Access Audit Site Report

Big Spring State Park
100 State Park Rd 8
Big Spring, TX 79720
Accessibility Evaluation
Inspection Date: 12/13/2021
Inspectors: Tanya Scheibe

Prepared By
WT Group

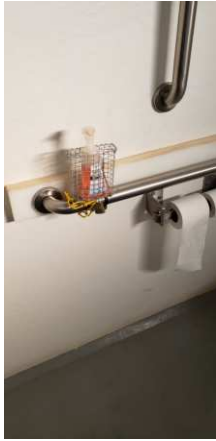
Finding Number	Area Description	Lat/Long	Finding	As Built	Recommendation	Citation	Photos	Figure
14	Exterior: Parking	[32.2301583, -101.4956174]	There are no accessible parking stalls. Each lot where parking is provided for the public as clients, guests or employees, shall provide accessible parking and shall be located on the shortest accessible route of travel from adjacent parking to an accessible entrance. There are an estimated total of 30 parking stalls in the parking lot that could be reasonably associated with this facility. There should be a minimum of 2 accessible stalls with a minimum of 1 being designed as van accessible.	Overlook pulloff - no accessible Stalls. 0 of approx 30 accessible	Create one or more 8' accessible parking stalls, with one 5' adjacent access aisle, with proper signage and striping based on the total number of stalls	2015 ABAAS Section: F208.2 2012 TAS Section: 208.2 2010 ADAS Section: 208.2

15	Exterior: Parking	[32.2321935, -101.4906795]	The access aisle is not a minimum 5 feet wide. A car accessible parking stall's access aisle must be a minimum of 5 feet wide measured from centerline to centerline. Where the access aisle is not adjacent to another parking space or access aisle, measurements shall be permitted to include the full width of the line defining the access aisle.	HQ parking - access aisle is 56", the accessible stall is over 12' wide	Repaint access aisles to be 5' each	2015 ABAAS Section: 502.3.1 2012 TAS Section: 502.3.1 2010 ADAS Section: 502.3.1

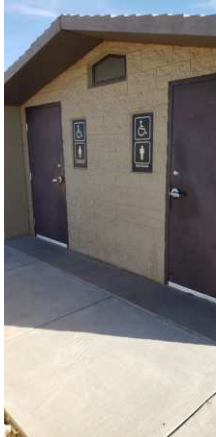
Finding Number	Area Description	Lat/Long	Finding	As Built	Recommendation	Citation	Photos	Figure
16	Exterior: Parking	[32.2319031, -101.4907854]	There are no accessible parking stalls. Each lot where parking is provided for the public as clients, guests or employees, shall provide accessible parking and shall be located on the shortest accessible route of travel from adjacent parking to an accessible entrance. There are a total of 4 parking stalls in the parking lot that could be reasonably associated with this facility. There should be a minimum of 1 accessible stalls with a minimum of 1 being designed as van accessible.	0 of 4 stalls marked accessible at lot for restroom 2	Create one or more 8' accessible parking stalls, with one 5' adjacent access aisle, with proper signage and striping based on the total number of stalls	2015 ABAAS Section: F208.2 2012 TAS Section: 208.2 2010 ADAS Section: 208.2

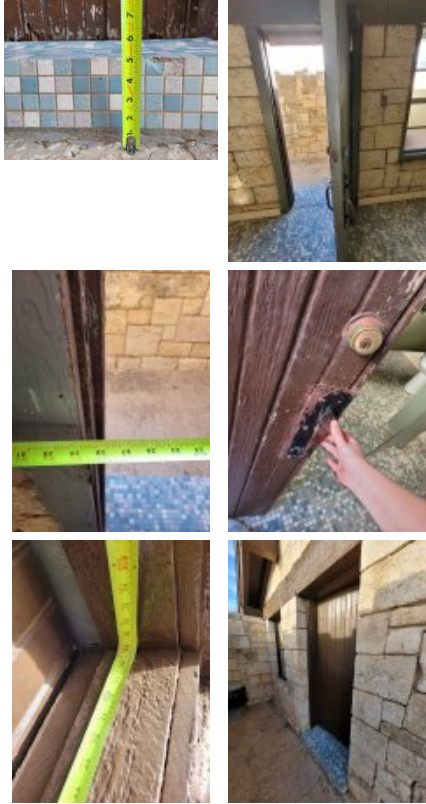
Finding Number	Area Description	Lat/Long	Finding	As Built	Recommendation	Citation	Photos	Figure
24	Restrooms: Restrooms 2	[32.2318192 , -101.4906 996]	Door openings shall provide a clear width of 32 inches (815 mm) minimum. Clear openings of doorways with swinging doors shall be measured between the face of the door and the stop, with the door open 90 degrees. Openings more than 24 inches (610 mm) deep shall provide a clear opening of 36 inches (915 mm) minimum. There shall be no projections into the required clear opening width lower than 34 inches (865 mm) above the finish floor or ground. Projections into the clear opening width between 34 inches (865 mm) and 80 inches (2030 mm) above the finish floor or ground shall not exceed 4 inches (100 mm). The threshold has a vertical change greater than 1/4 inch high. The threshold at a doorway shall be no higher than 1/2 inch. Changes in level between 1/4 inch and 1/2 inch must be beveled at 1:2 or less. 1/4 inch is the maximum vertical rise. Exterior doors are recommended to be maintained at 8.5 lbf as a smart practice. Force is to be measured at the operating hardware or 30 inches from the hinges, whichever is greater. Hand-activated door opening hardware, handles, pulls, latches, locks, and other operating devices on accessible doors shall have a shape that is easy to grasp with one hand and does not require tight grasping, tight pinching or twisting of the wrist to operate. Hardware shall be 34 inches minimum and 48 inches maximum above the finish floor or ground.	men's - 30#, doesn't open 90 degrees, 5" CIL, 30" width, requires pinch, 77.5" overhead	For all doors along the public circulation route, replace doors with doors having 80" overhead clearance and 32" clear width For all doors along the public circulation route, repair, bevel, or ramp CILs at door entries to max .25" For all doors along the public circulation route, inspect, adjust, and maintain 8.5 lbf to open exterior doors as a smart practice For all doors along the public circulation route, replace hardware with lever hardware or hardware operable without a tight pinch or grasp	2010 ADAS Section: 404.2.3, 404.2.7, 404.2.4, 404.2.11, 404.2.11 Exception

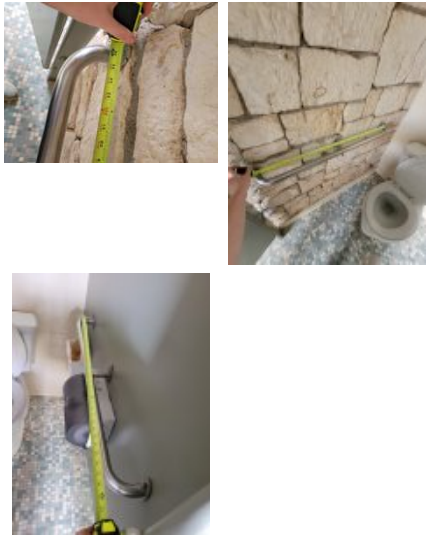
Finding Number	Area Description	Lat/Long	Finding	As Built	Recommendation	Citation	Photos	Figure
28	Restrooms: Restrooms 2	[32.2318214 , -101.4907 049]	The ambulatory stall is not between 35" to 37" wide and 60" deep.	men's - 39" by 60"	Correct ambulatory stall to be 35" to 37" wide and minimum 60" deep	2015 ABAAS Section: 604.8.2.1 2012 TAS Section: 604.8.2.1 2010 ADAS Section: 604.8.2.1		
29	Restrooms: Restrooms 2	[32.2318226 , -101.4906 982]	The toilet is not located within the range to the side wall or partition. The centerline of the toilet shall be 17 inches minimum and 19 inches maximum side wall or partition in the ambulatory accessible toilet compartment.	men's - 22.5" from toilet paper side	Remount toilet to 17" to 19" from the side wall to center line in ambulatory stalls	2015 ABAAS Section: 604.9.1 2012 TAS Section: 604.9.1 2010 ADAS Section: 604.9.1		
30	Restrooms: Restrooms 2	[32.2318214 , -101.4907 023]	The stall door fails to comply with all of the door requirements. The stall door must be a minimum of 32" wide and have compliant hardware on both sides. The stall door must be self-closing.	men's - stall door not self closing	Adjust stall door to be self-closing	2015 ABAAS Section: 404.2.3, 404.2.7, 604.8.2.2 2012 TAS Section: 404.2.3, 404.2.7, 604.8.2.2 2010 ADAS Section: 404.2.3, 404.2.7, 604.8.2.2

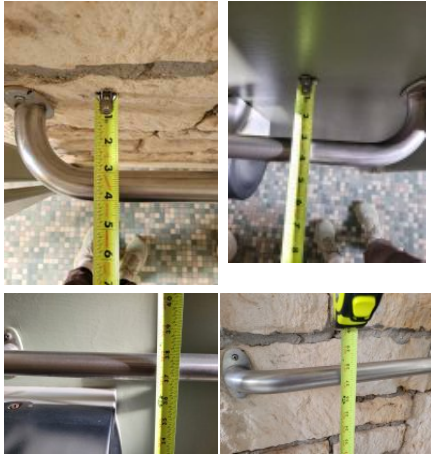
Finding Number	Area Description	Lat/Long	Finding	As Built	Recommendation	Citation	Photos	Figure
31	Restrooms: Restrooms 2	[32.2318158 , -101.4906 982]	Grab bars shall comply with 609. A side-wall grab bar complying with 604.5.1 shall be provided on both sides of the compartment. The space between the wall and the grab bar shall be 1½ inches (38 mm). The space between the grab bar and projecting objects below and at the ends shall be 1½ inches (38 mm) minimum. The space between the grab bar and projecting objects above shall be 12 inches (305 mm) minimum. Grab bars shall be installed in a horizontal position, 33 inches (840 mm) minimum and 36 inches (915 mm) maximum above the finish floor measured to the top of the gripping surface, except that at water closets for children's use complying with 604.9, grab bars shall be installed in a horizontal position 18 inches (455 mm) minimum and 27 inches (685 mm) max	men's - both grab bars 36" long	Replace or add side grab bars with a 42" long grab bar, mounted max 12" from the rear wall at the close end and min 54" on the far end and 33" to 36" aff	2015 ABAAS Section: 604.8.2.3, 609.3, 609.4 2012 TAS Section: 609.4, 609.3, 604.8.2.3 2010 ADAS Section: 609.3, 609.4, 604.8.2.3

32	Restrooms: Restrooms 2	[32.2318237 , -101.4906 969]	The grab bar height and/or spacing fails. Grab bars must be mounted between 33" and 36" to the top of the gripping surface. There must be 1.5" of clearance between the grab bar and the wall. There must be a minimum of 1.5" of clearance below and minimum 12" above the grab bar to any dispenser or other obstruction.	men's - 3" clearance between wall and grab bar, both 38" aff	Remount grab bars in accessible stall to 33" to 36" aff Replace grab bars in accessible stall with bars that provide 1.5" clearance between the grab bar and the wall	2015 ABAAS Section: 609.3, 609.4 2012 TAS Section: 609.4, 609.3 2010 ADAS Section: 609.3, 609.4

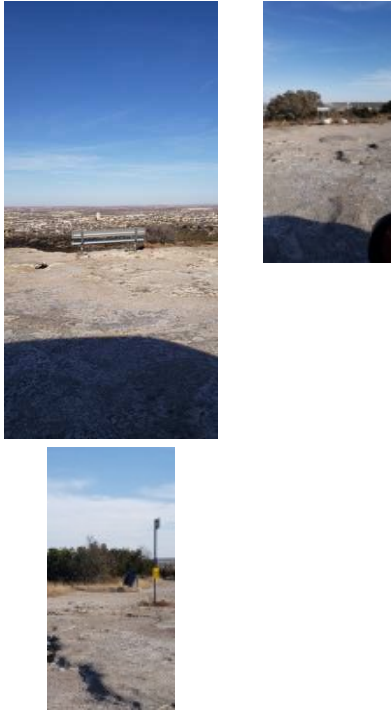
Finding Number	Area Description	Lat/Long	Finding	As Built	Recommendation	Citation	Photos	Figure
33	Restrooms: Restrooms 2	[32.2318192 , -101.4906 969]	Door openings shall provide a clear width of 32 inches (815 mm) minimum. Clear openings of doorways with swinging doors shall be measured between the face of the door and the stop, with the door open 90 degrees. Openings more than 24 inches (610 mm) deep shall provide a clear opening of 36 inches (915 mm) minimum. There shall be no projections into the required clear opening width lower than 34 inches (865 mm) above the finish floor or ground. Projections into the clear opening width between 34 inches (865 mm) and 80 inches (2030 mm) above the finish floor or ground shall not exceed 4 inches (100 mm). The threshold has a vertical change greater than 1/4 inch high. The threshold at a doorway shall be no higher than 1/2 inch. Changes in level between 1/4 inch and 1/2 inch must be beveled at 1:2 or less. 1/4 inch is the maximum vertical rise. Exterior doors are recommended to be maintained at 8.5 lbf as a smart practice. Force is to be measured at the operating hardware or 30 inches from the hinges, whichever is greater. Hand-activated door opening hardware, handles, pulls, latches, locks, and other operating devices on accessible doors shall have a shape that is easy to grasp with one hand and does not require tight grasping, tight pinching or twisting of the wrist to operate. Hardware shall be 34 inches minimum and 48 inches maximum above the finish floor or ground.	women's restroom door - 28# push, doesn't open 90 degrees, 5" CIL, 28" width, hardware requires pinch, 75" overhead	For all doors along the public circulation route, replace doors with doors having 80" overhead clearance and 32" clear width For all doors along the public circulation route, repair, bevel, or ramp CILs at door entries to max .25" For all doors along the public circulation route, inspect, adjust, and maintain 8.5 lbf to open exterior doors as a smart practice For all doors along the public circulation route, replace hardware with lever hardware or hardware operable without a tight pinch or grasp	2010 ADAS Section: 404.2.3, 404.2.7, 404.2.4, 404.2.11, 404.2.11 Exception

34	Restrooms: Restrooms 2	[32.2318282 , -101.4906 996]	The mirror is mounted too high. Mirrors must have the bottom edge of the reflecting surface a maximum of 40 inches above the floor if above a sink or counter. Mirrors not located above lavatories or countertops shall be installed with the bottom edge of the reflecting surface 35 inches maximum above the finish floor or ground.	women's - mirror 47" aff	Lower mirror so reflective surface is max 40" aff	2015 ABAAS Section: 603.3 2012 TAS Section: 603.3 2010 ADAS Section: 603.3

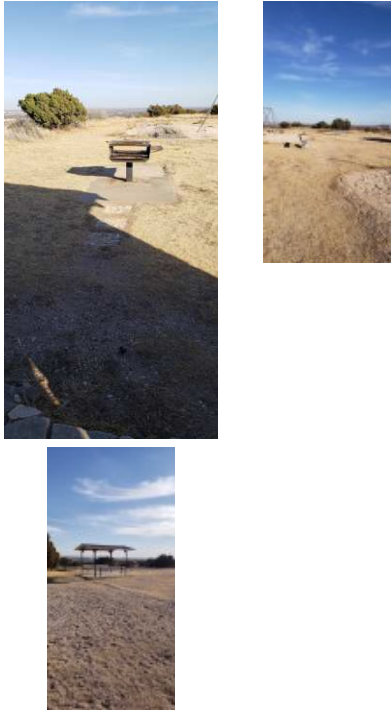
Finding Number	Area Description	Lat/Long	Finding	As Built	Recommendation	Citation	Photos	Figure
37	Restrooms: Restrooms 2	[32.2318226 , -101.4906 969]	The ambulatory stall is not between 35" to 37" wide and 60" deep.	women's - 39" by 55.5"	Correct ambulatory stall to be 35" to 37" wide and minimum 60" deep	2015 ABAAS Section: 604.8.2.1 2012 TAS Section: 604.8.2.1 2010 ADAS Section: 604.8.2.1		
38	Restrooms: Restrooms 2	[32.2318192 , -101.4907 157]	The toilet is not located within the range to the side wall or partition. The centerline of the toilet shall be 17 inches minimum and 19 inches maximum side wall or partition in the ambulatory accessible toilet compartment.	women's - 21" from toilet paper side	Remount toilet to 17" to 19" from the side wall to center line in ambulatory stalls	2015 ABAAS Section: 604.9.1 2012 TAS Section: 604.9.1 2010 ADAS Section: 604.9.1

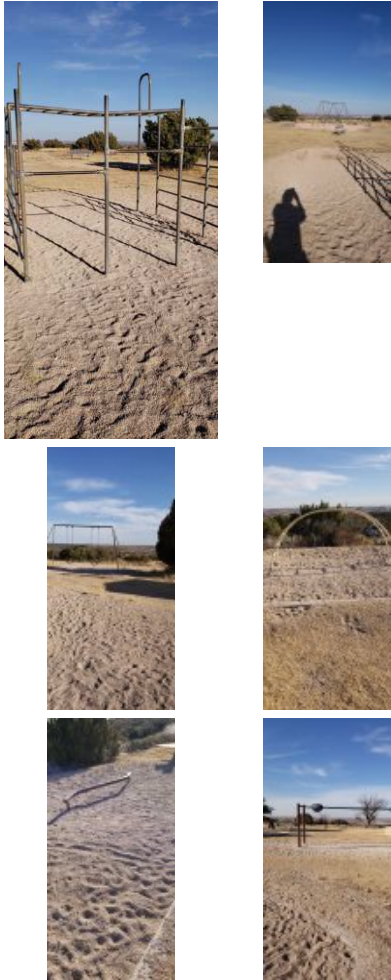
Finding Number	Area Description	Lat/Long	Finding	As Built	Recommendation	Citation	Photos	Figure
49	Park Site: Residence	[32.2297522 , -101.48961 6]	Spaces and elements within employee work areas shall only be required to comply with 206.2.8, 207.1, and 215.3 and shall be designed and constructed so that individuals with disabilities can approach, enter, and exit the employee work area. Employee work areas, or portions of employee work areas, other than raised courtroom stations, that are less than 300 square feet (28 m2) and elevated 7 inches (180 mm) or more above the finish floor or ground where the elevation is essential to the function of the space shall not be required to comply with these requirements or to be on an accessible route.	no accesible route to residence door	Create an accessible route to the residence entry	2015 ABAAS Section: F203.9 2012 TAS Section: 203.9 2010 ADAS Section: 203.9
